UNITED STATES PATENT AND TRADEMARK OFFICE

| APPLICATION NO. | FILING DATE | FIRST NAMED INVENTOR | ATTORNEY DOCKET NO. | CONFIRMATION NO. |
|-----------------|-------------|----------------------|---------------------|------------------|
| 10/656,653 | 09/03/2003 | Daniel J. Cook | 14/1454US | 8300 |

| Office Action Summary | Application No. | | Applicant(s) | |

DETAILED ACTION

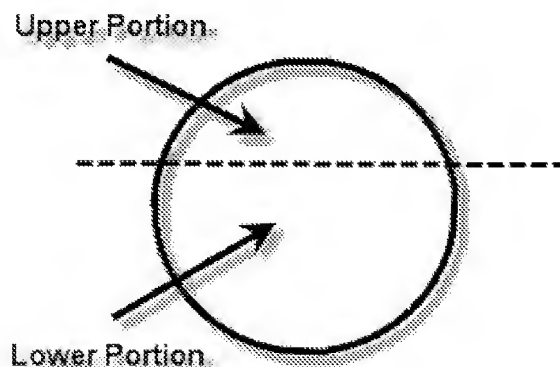
Brain further discloses a laryngeal mask having a distal lumen, wherein the distal lumen is a circular lumen, which can have an upper portion and a lower portion, and which is still smaller than the diameter of the tube adapter at the proximal end. The distal lumen can be divided into asymmetrical halves so that the upper portion can have a diameter that is different from the lower portion. See figure below.

The applicant's argument that Brain fails to teach the limitations of claim 43 is not persuasive because the claim does not specifically recite a "keyhole". Instead, the claim merely recites a lumen having an upper portion and a lower portion. As seen above, a circular lumen can be sectioned off to an upper portion and a lower portion, wherein the upper portion has a diameter that is different from the lower portion.
